**ADDENDUM NO. 1**

RE: Indiana University  
Bloomington BL053 -  
IMU Biddle Hotel –  
Data Upgrades

PROJECT No. 20222853

DATE: May 28, 2024

FIRST FLOOR ELECTRICAL PLAN

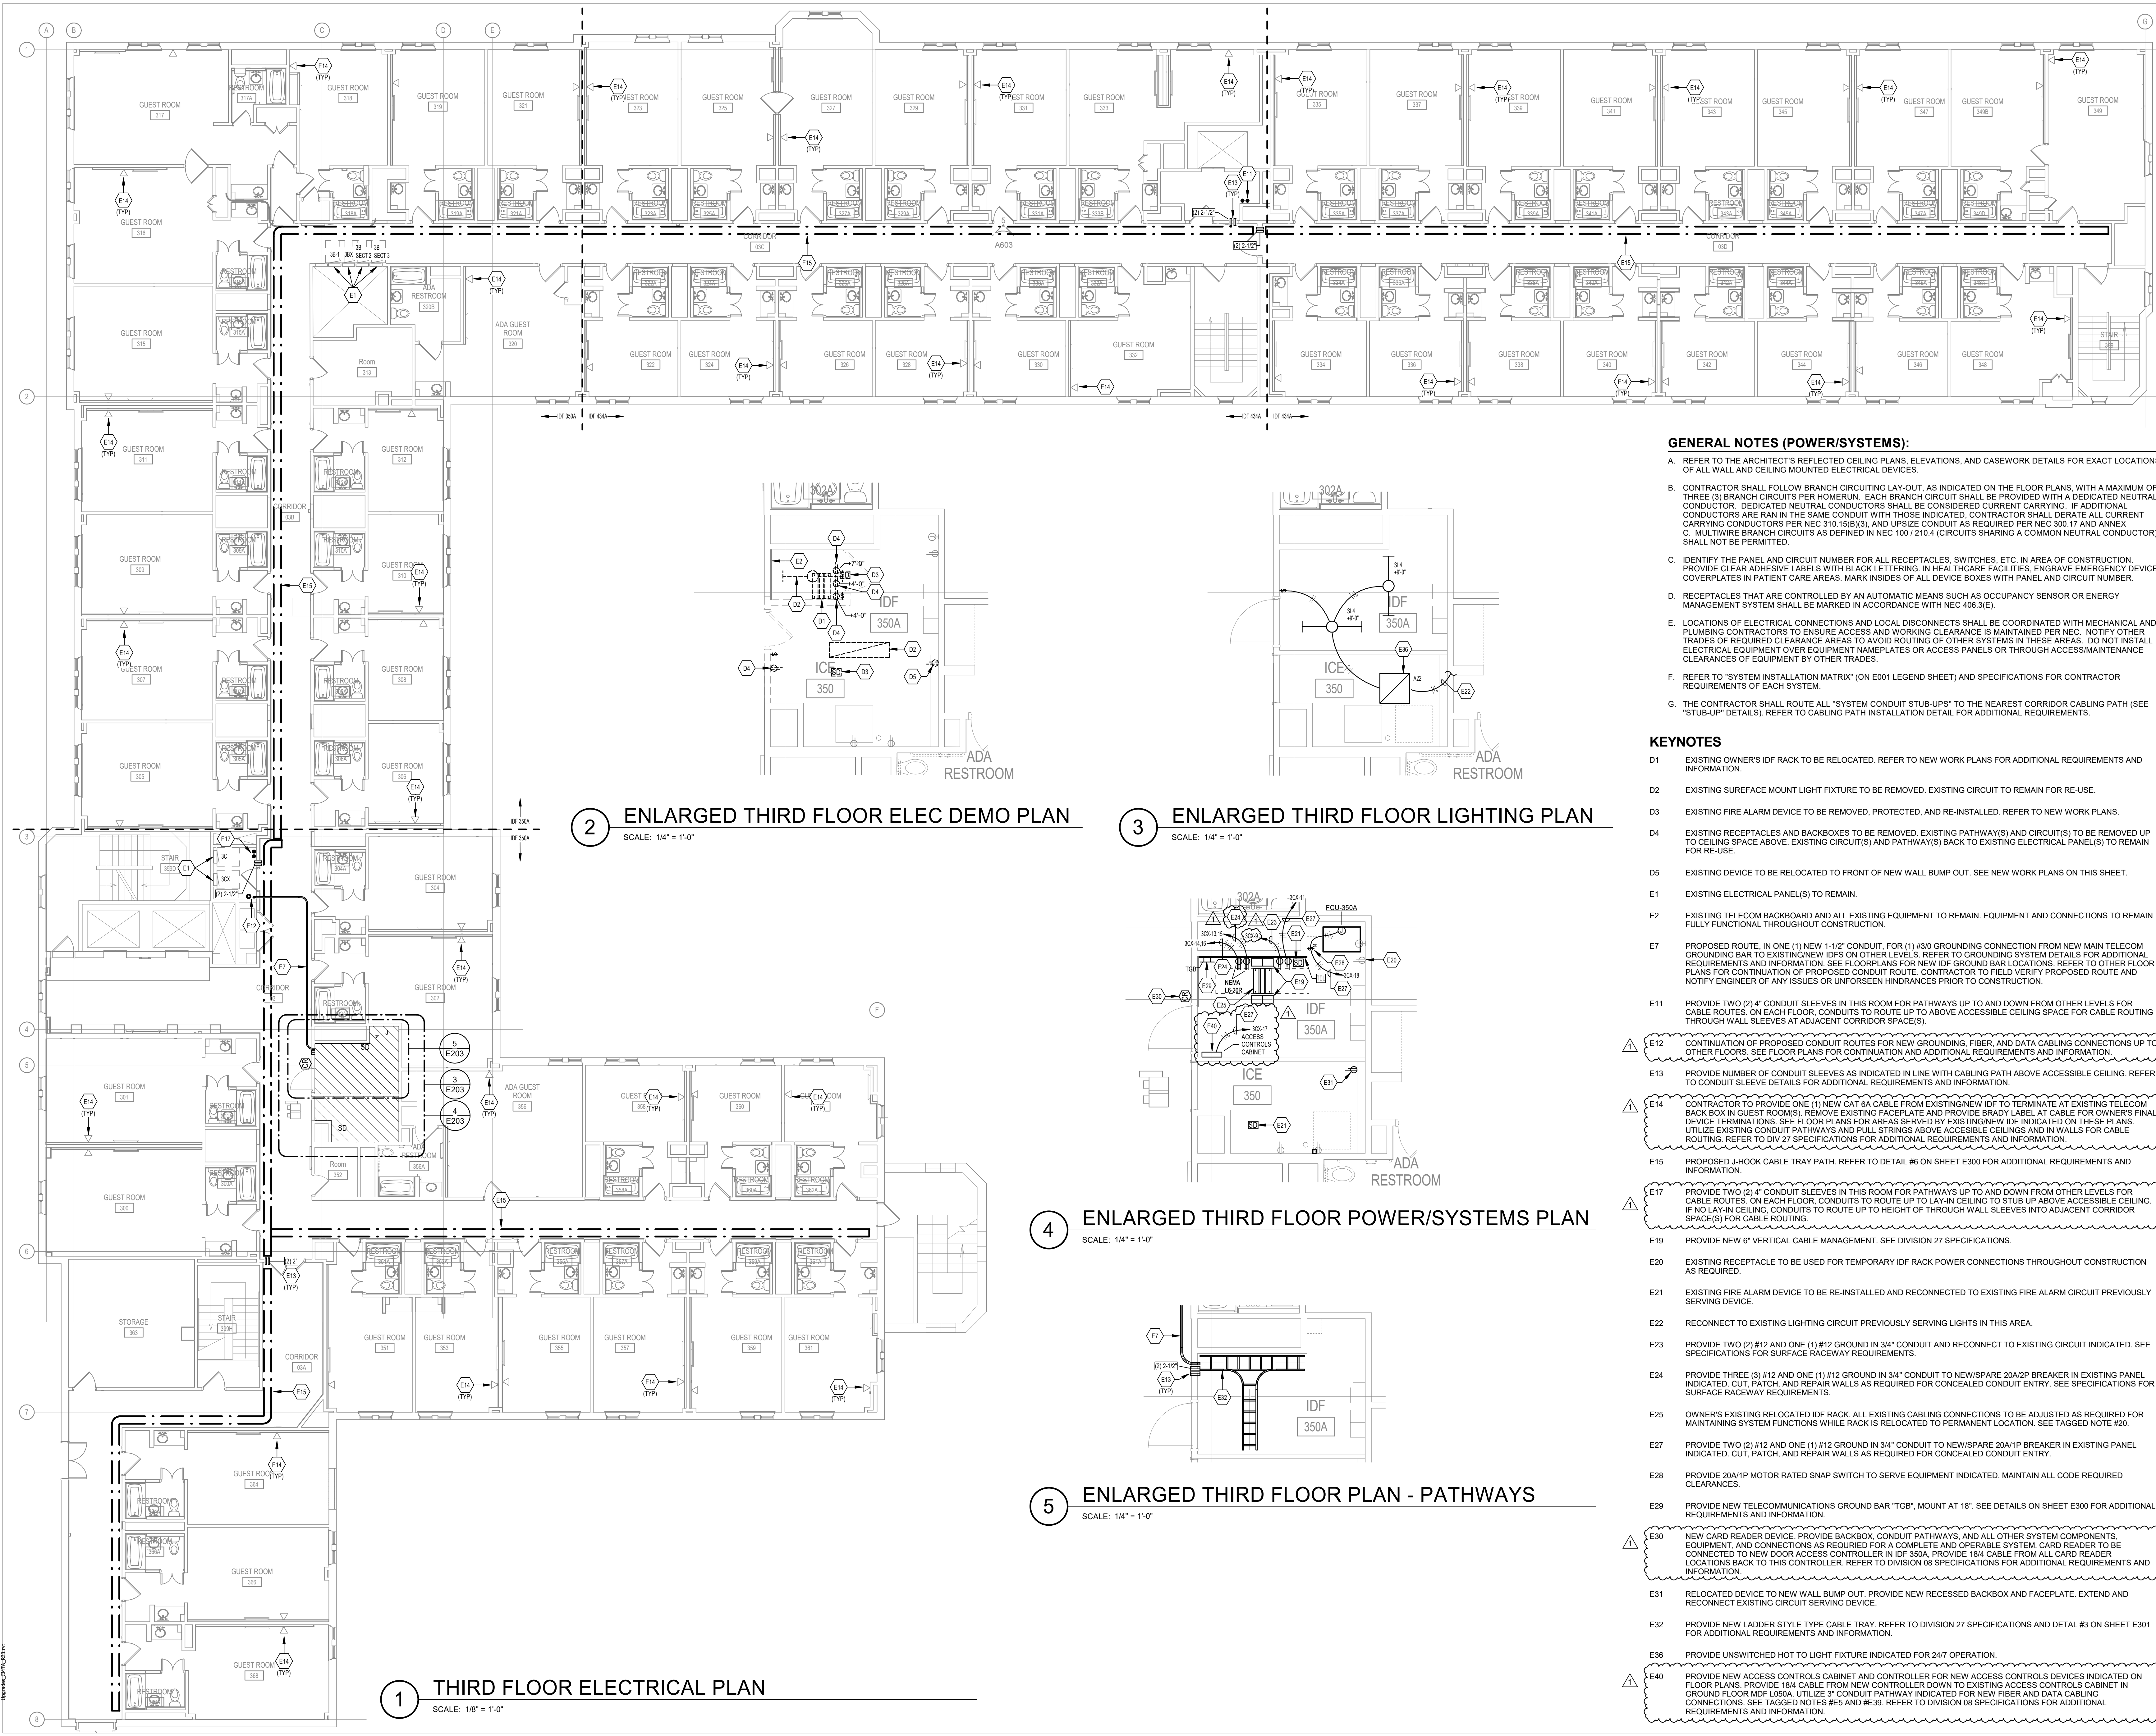
3. Sheet E101 – MAIN FLOOR - INTERCONNECTION PLAN
  - a. Revised tagged note #E12.
4. Sheet E201 – FIRST FLOOR ELECTRICAL PLAN
  - a. Revised tagged notes #E12, #E14, and #E17.

- E12 CONTINUATION OF PROPOSED CONDUIT ROUTES FOR NEW GROUNDING, FIBER, AND DATA CABLING CONNECTIONS UP TO OTHER FLOORS. SEE FLOOR PLANS FOR CONTINUATION AND ADDITIONAL REQUIREMENTS AND INFORMATION.

- E14 CONTRACTOR TO PROVIDE ONE (1) NEW CAT 6A CABLE FROM EXISTING/NEW IDF TO TERMINATE AT EXISTING TELECOM BACK BOX IN GUEST ROOM(S). REMOVE EXISTING FACEPLATE AND PROVIDE BRADY LABEL AT CABLE FOR OWNER'S FINAL DEVICE TERMINATIONS. SEE FLOOR PLANS FOR AREAS SERVED BY EXISTING/NEW IDF INDICATED ON THESE PLANS. UTILIZE EXISTING CONDUIT PATHWAYS AND PULL STRINGS ABOVE ACCESSIBLE CEILINGS AND IN WALLS FOR CABLE ROUTING. REFER TO DIV 27 SPECIFICATIONS FOR ADDITIONAL REQUIREMENTS AND INFORMATION.

- E15 PROPOSED J-HOOK CABLE TRAY PATH. REFER TO DETAIL #6 ON SHEET E300 FOR ADDITIONAL REQUIREMENTS AND INFORMATION.
- E17 PROVIDE TWO (2) 4" CONDUIT SLEEVES IN THIS ROOM FOR PATHWAYS UP TO AND DOWN FROM OTHER LEVELS FOR CABLE ROUTES. ON EACH FLOOR, CONDUITS TO ROUTE UP TO LAY-IN CEILING TO STUB UP ABOVE ACCESSIBLE CEILING. IF NO LAY-IN CEILING, CONDUITS TO ROUTE UP TO HEIGHT OF THROUGH WALL SLEEVES INTO ADJACENT CORRIDOR SPACE(S) FOR CABLE ROUTING.

THIRD FLOOR ELECTRICAL PLAN

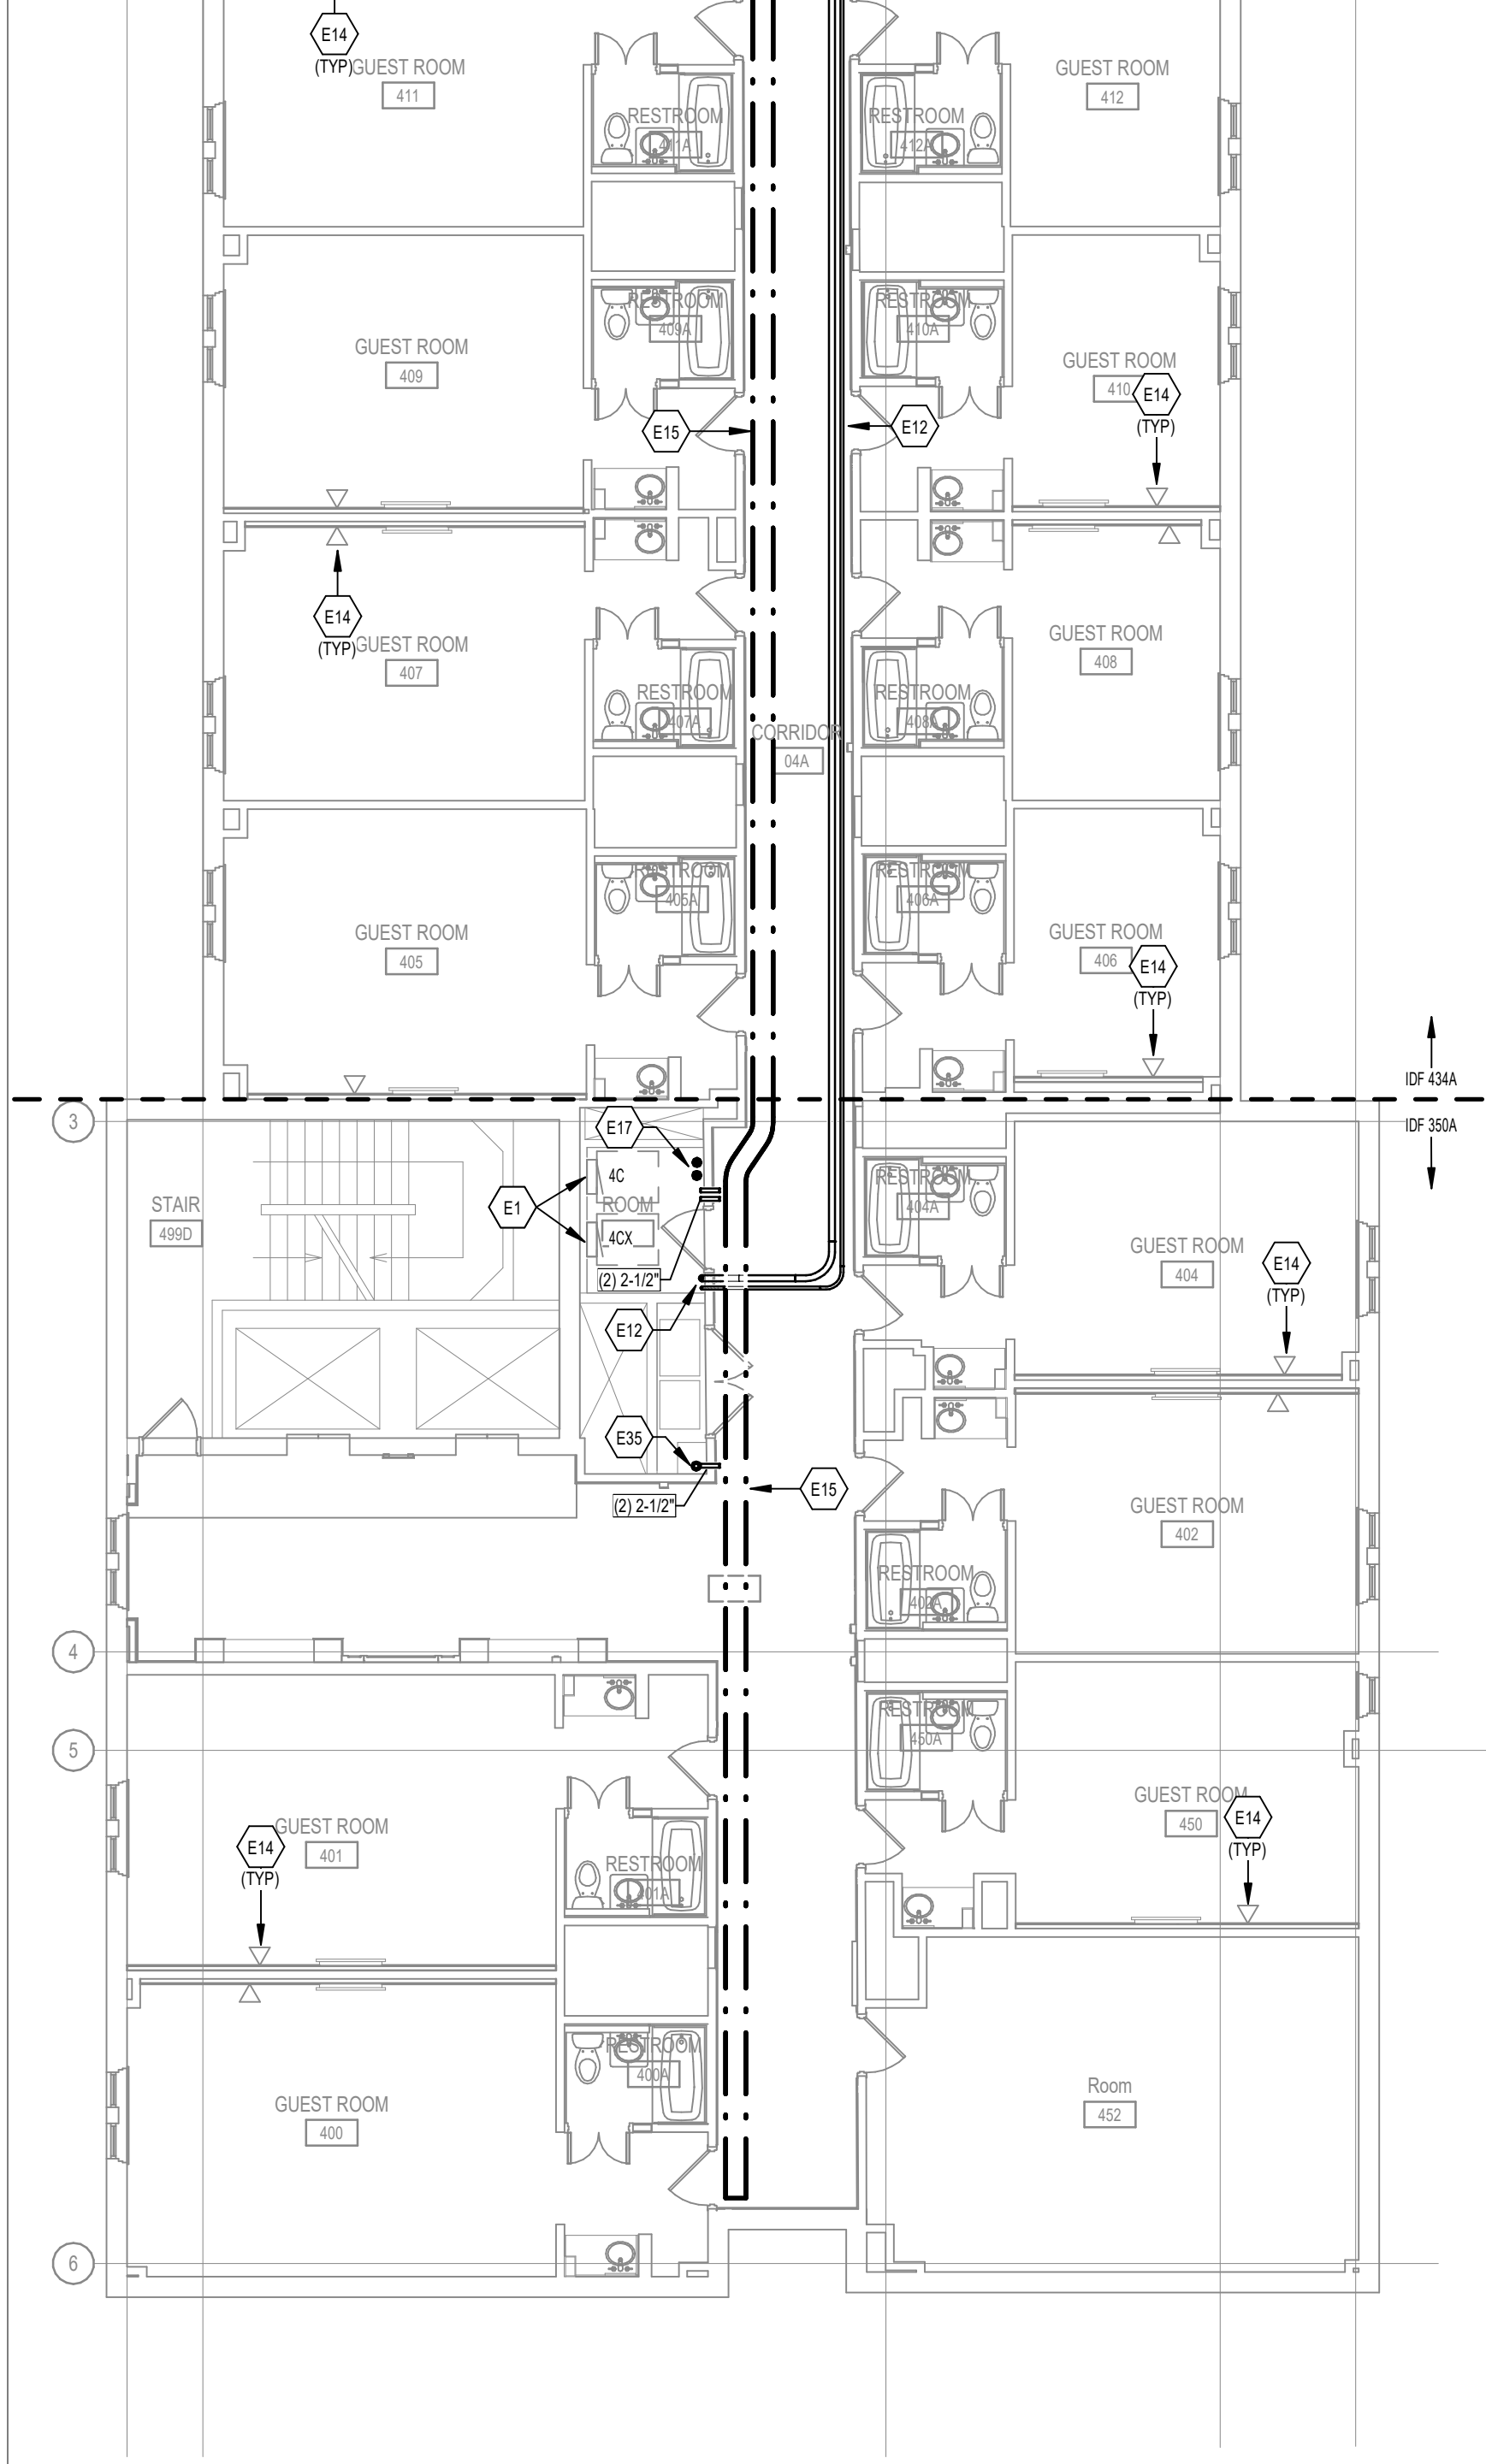
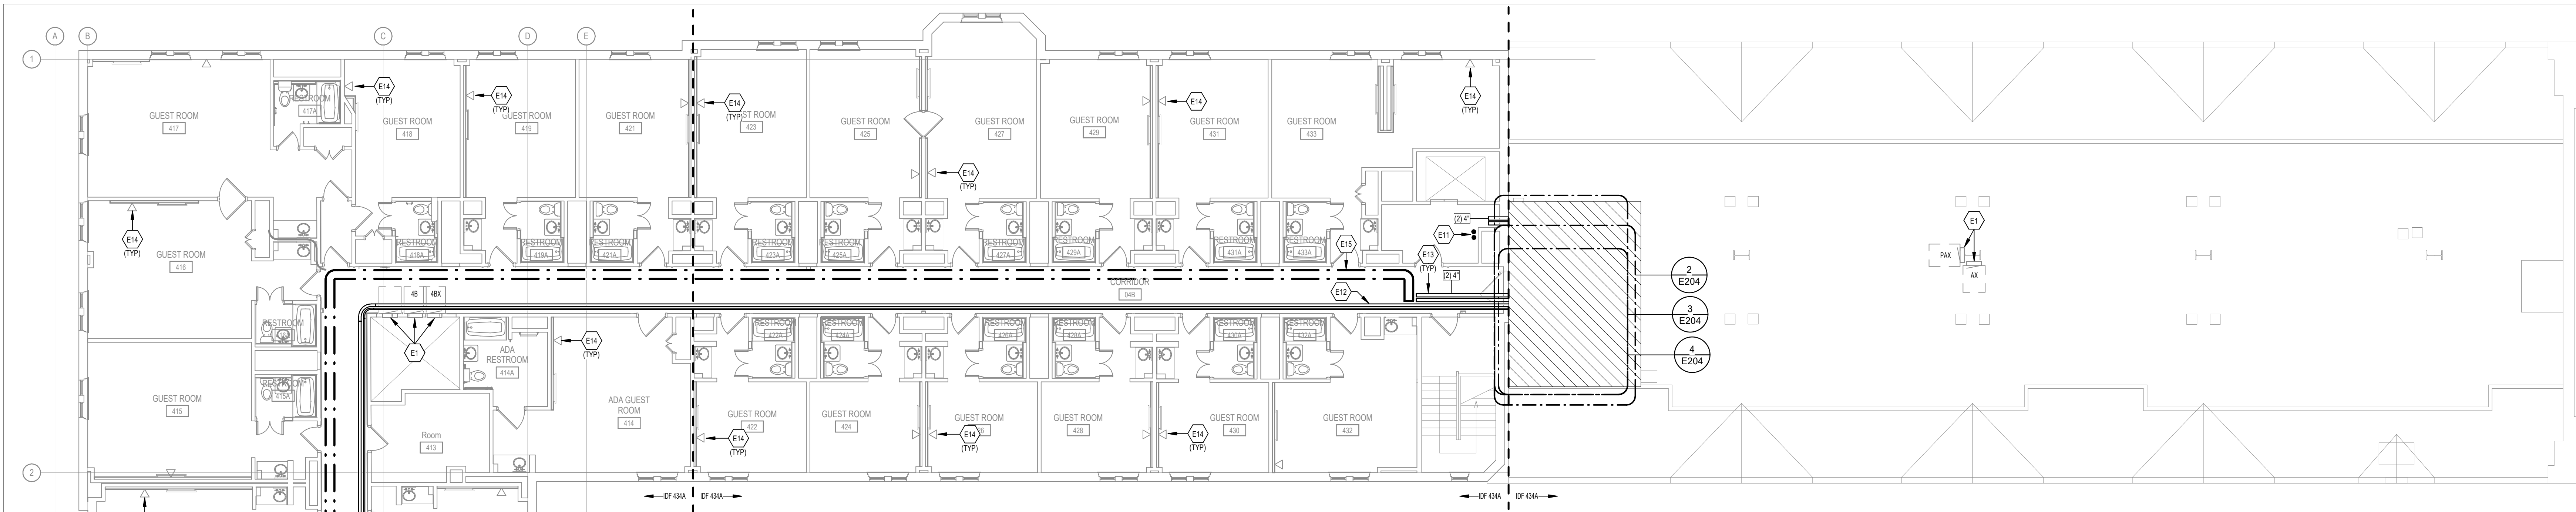
5. Sheet E202 – SECOND FLOOR ELECTRICAL PLAN
  - a. Revised tagged notes #E12, #E14, and #E17.
6. Sheet E203 – THIRD FLOOR ELECTRICAL PLAN
  - a. Revised tagged notes #E12, #E14, #E17, and #E30. Added tagged note #E40.

- b. New door access controller location indicated in IDF 350A. See added tagged note #E40.
  - c. Revised circuit designation for receptacle power.
  - d. Mislabeled tagged note corrected to #E24.

- E12 CONTINUATION OF PROPOSED CONDUIT ROUTES FOR NEW GROUNDING, FIBER, AND DATA CABLING CONNECTIONS UP TO OTHER FLOORS. SEE FLOOR PLANS FOR CONTINUATION AND ADDITIONAL REQUIREMENTS AND INFORMATION.

- E14 CONTRACTOR TO PROVIDE ONE (1) NEW CAT 6A CABLE FROM EXISTING NEW IDF TO TERMINATE AT EXISTING TELECOM BACK BOX IN GUEST ROOMS. REMOVE EXISTING FACEPLATE AND PROVIDE BRADY LABEL. AT CABLE FOR OWNER'S FINAL DEVICE TERMINATIONS. SEE FLOOR PLANS FOR AREAS SERVED BY EXISTING NEW IDF INDICATED ON THESE PLANS. UTILIZE EXISTING CONDUIT PATHWAYS AND PULL STRINGS ABOVE ACCESSIBLE CEILINGS AND IN WALLS FOR CABLE ROUTING. REFER TO DIV 27 SPECIFICATIONS FOR ADDITIONAL REQUIREMENTS AND INFORMATION.

- E15 PROPOSED J-HOOK CABLE TRAY PATH. REFER TO DETAIL #6 ON SHEET E300 FOR ADDITIONAL REQUIREMENTS AND INFORMATION.
- E17 PROVIDE TWO (2) 4" CONDUIT SLEEVES IN THIS ROOM FOR PATHWAYS UP TO AND DOWN FROM OTHER LEVELS FOR CABLE ROUTES. ON EACH FLOOR, CONDUITS TO ROUTE UP TO LAY-IN CEILING TO STUB UP ABOVE ACCESSIBLE CEILING IF NO LAY-IN CEILING. CONDUITS TO ROUTE UP TO HEIGHT OF THROUGH WALL SLEEVES INTO ADJACENT CORRIDOR SPACE(S) FOR CABLE ROUTING.

- E30 NEW CARD READER DEVICE. PROVIDE BACKBOX, CONDUIT PATHWAYS, AND ALL OTHER SYSTEM COMPONENTS, EQUIPMENT, AND CONNECTIONS AS REQUIRED FOR A COMPLETE AND OPERABLE SYSTEM. GARD READER TO BE CONNECTED TO NEW DOOR ACCESS CONTROLLER IN IDF 350A. PROVIDE 184 CABLE FROM ALL CARD READER LOCATIONS BACK TO THIS CONTROLLER. REFER TO DIVISION 08 SPECIFICATIONS FOR ADDITIONAL REQUIREMENTS AND INFORMATION.

- E38 PROVIDE UNSWITCHED HOT TO LIGHT FIXTURE INDICATED FOR 24/7 OPERATION.
- E40 PROVIDE NEW ACCESS CONTROLS CABINET AND CONTROLLER FOR NEW ACCESS CONTROLS DEVICES INDICATED ON FLOOR PLANS. PROVIDE 184 CABLE FROM NEW CONTROLLER DOWN TO EXISTING ACCESS CONTROLS CABINET IN GROUND FLOOR MDF ROOM. UTILIZE 3" CONDUIT PATHWAY INDICATED FOR NEW FIBER AND DATA CABLING CONNECTIONS. SEE TAGGED NOTES #E5 AND #E39. REFER TO DIVISION 08 SPECIFICATIONS FOR ADDITIONAL REQUIREMENTS AND INFORMATION.
